# Scientific Analysis Administrative Change Notice

<b>1. Document Number:</b>	ANL-MGR-GS-000004	<b>2. Revision:</b>	00	<b>3. ACN:</b>	01
<b>4. Title:</b>	Peak Ground Velocities for Seismic Events at Yucca Mountain, Nevada				
<b>5. No. of Pages Attached:</b>	1

Figure 6-8. Probability Distribution of Bounding Horizontal PGV

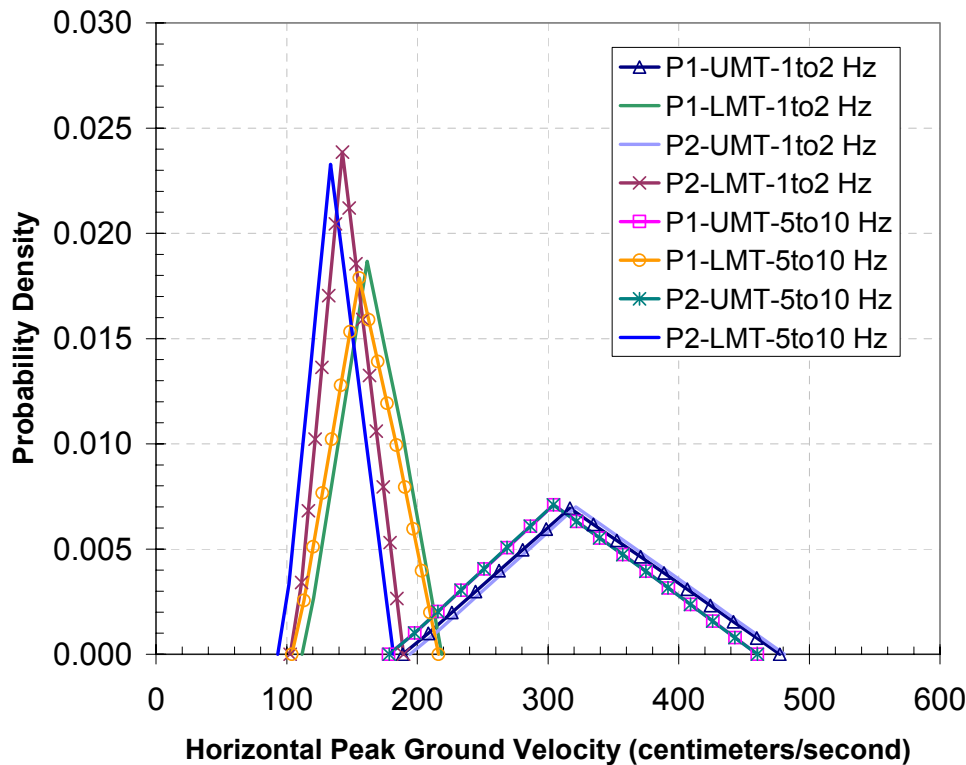
7. Affected Pages	8. Description of Change:
6-24	<p>Change to figure</p> <p>Figure 6-8 "Probability Distribution of Bounding Horizontal PGV", to correct the y-axis values (Probability Density).</p> <p>Note: Replacement of the existing version of Figure 6.8 in ANL-MGR-GS-000004 Rev 00 with the correct version does not affect the technical content of the report. The chart and worksheets in Appendix D of the report, from which the figure was taken and from which the product output were derived, are correct in the existing version. The figure in the report, however, was not updated during the check and review process when the figure in Appendix D changed in response to comments. Thus, correction of the figure in the report has no impact on the technical content of the report.</p> <p>This error was identified in CR 5323</p>
